FINAL DRAINAGE REPORT

PIKE SOLAR PLUS STORAGE PROJECT

EL PASO COUNTY, COLORADO

Engineering Review

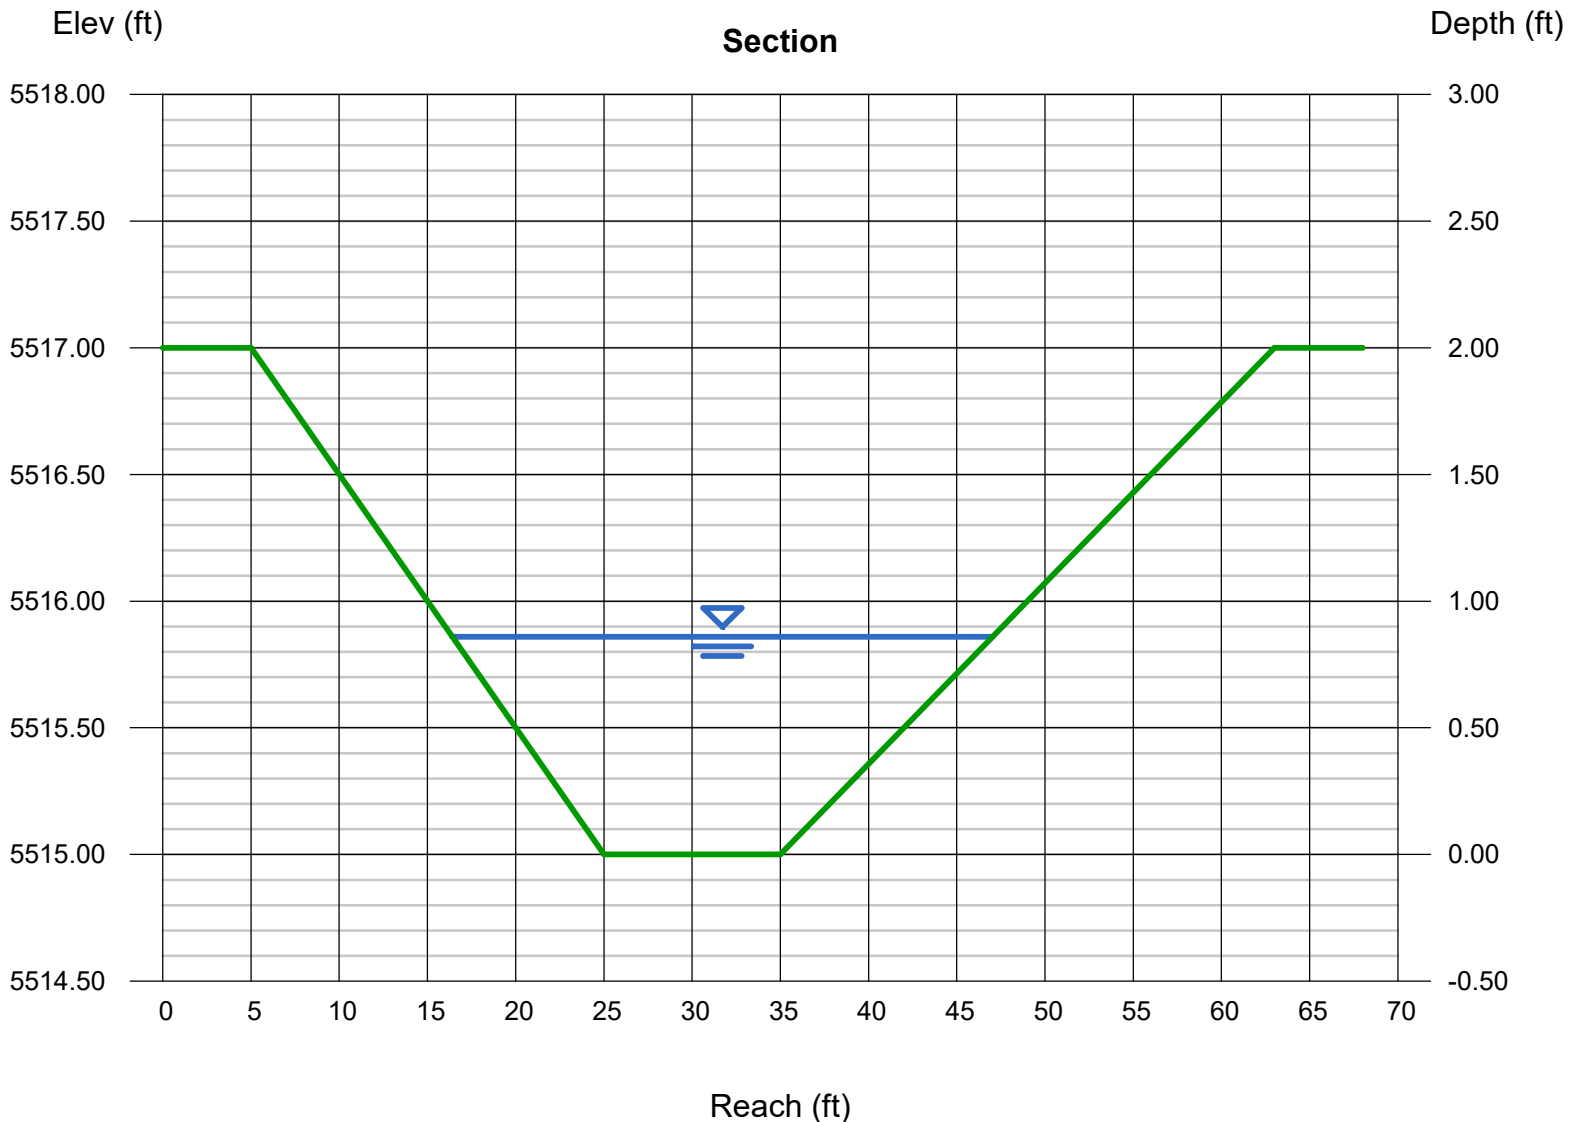
Add a note specifying
lining type for the
supercritical flow.

FLOODPLAIN CROSSING #1 (43+00-54+00)

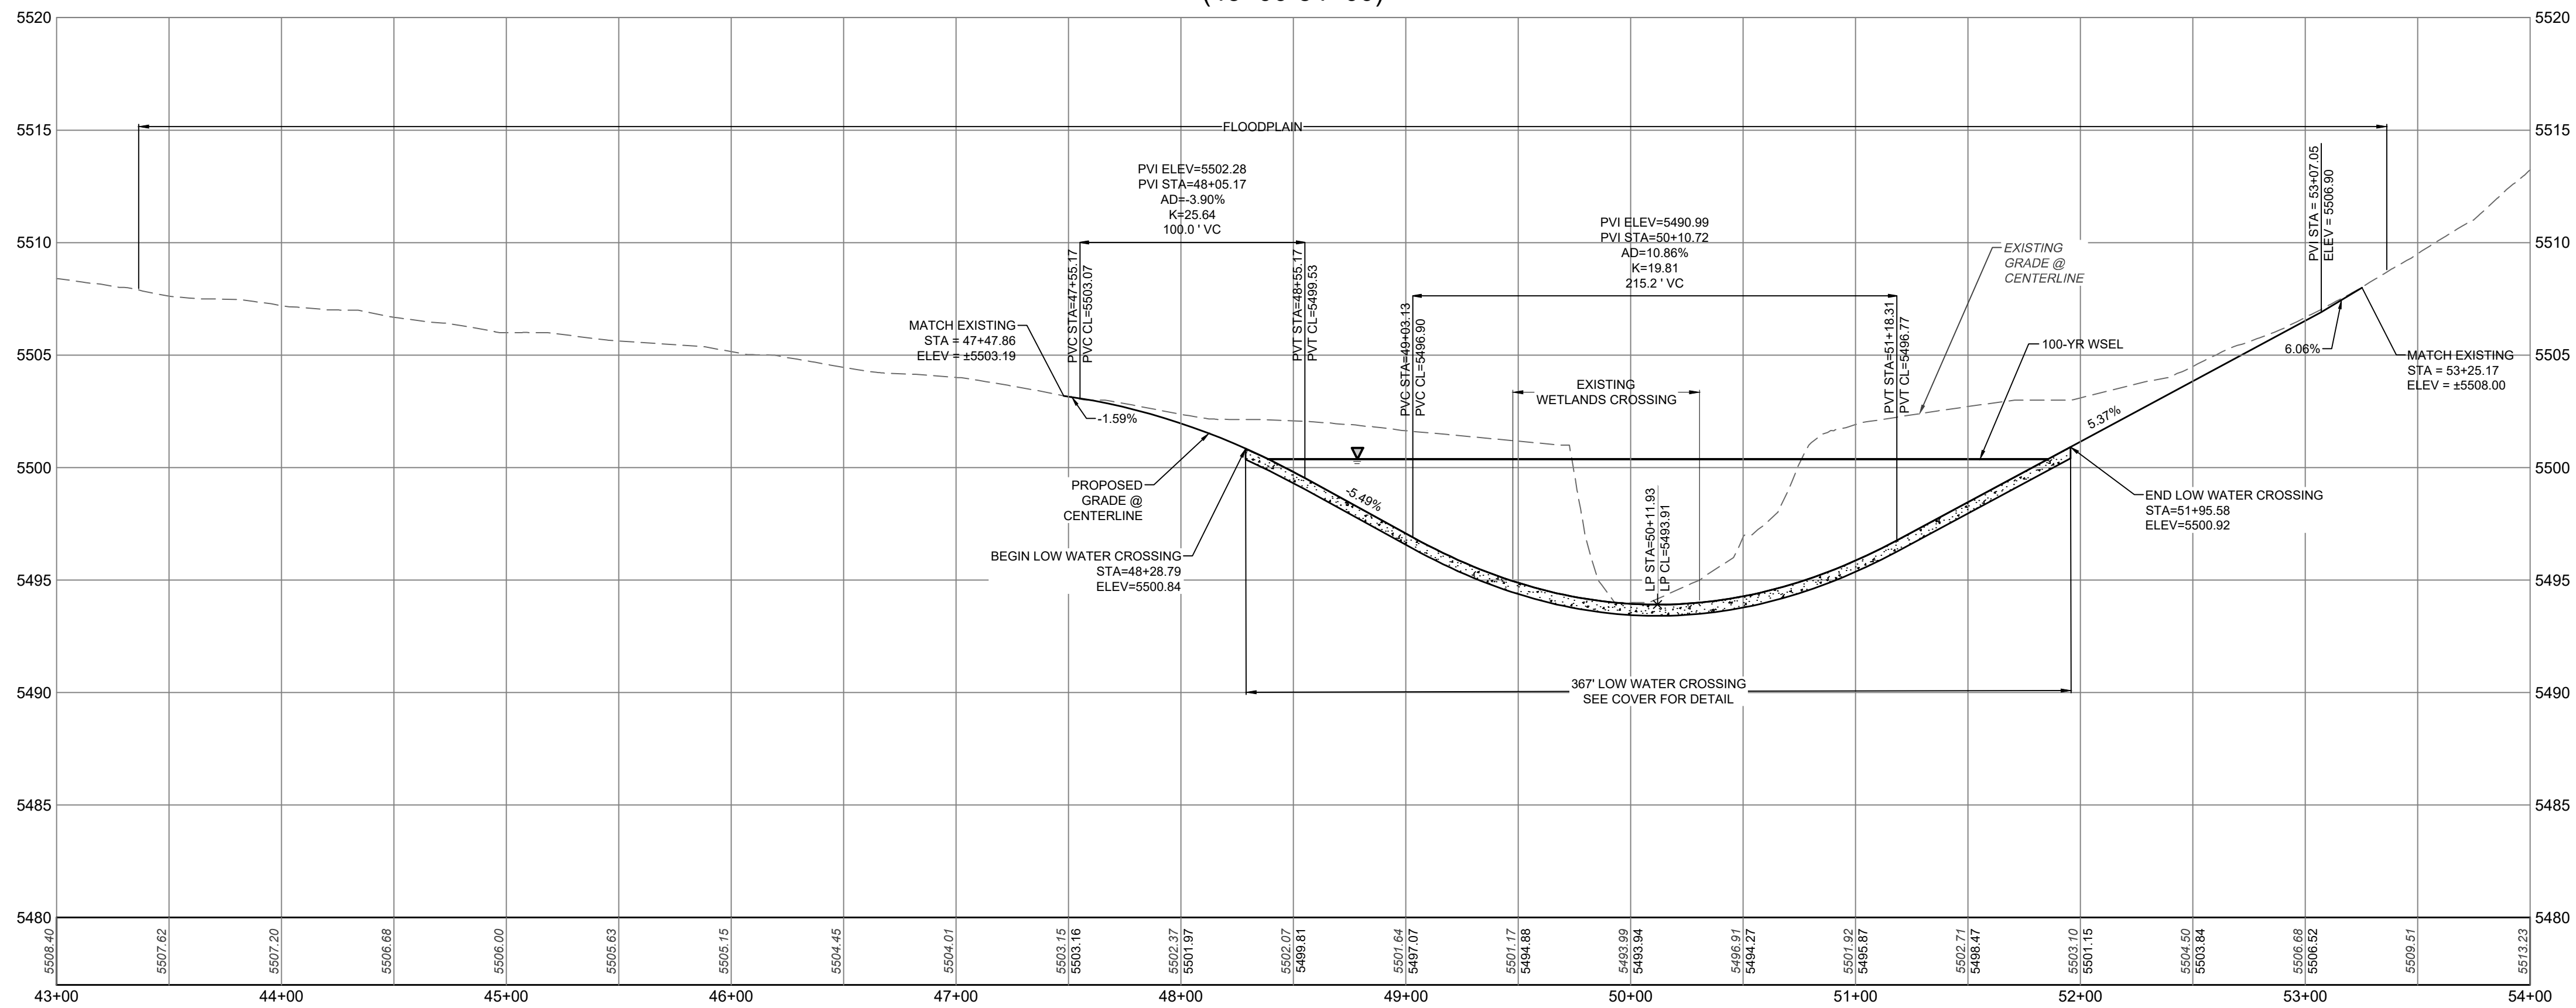
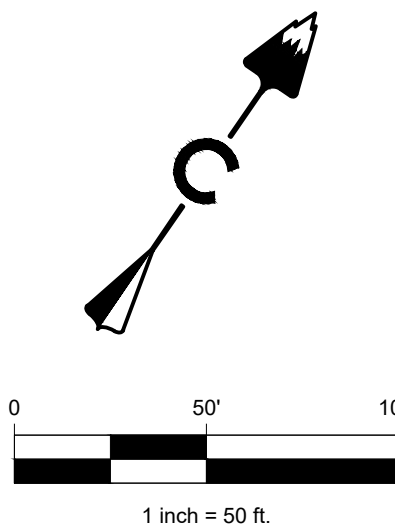
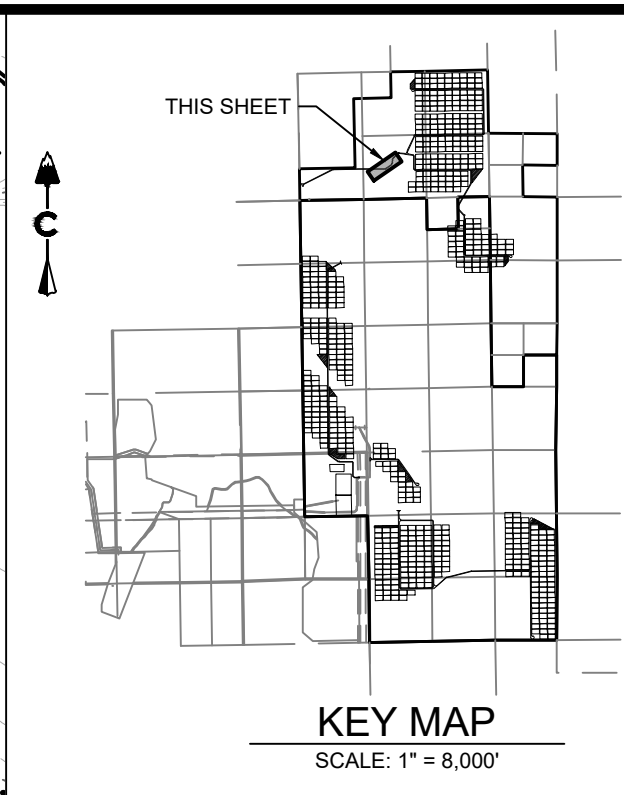
Label proposed
material
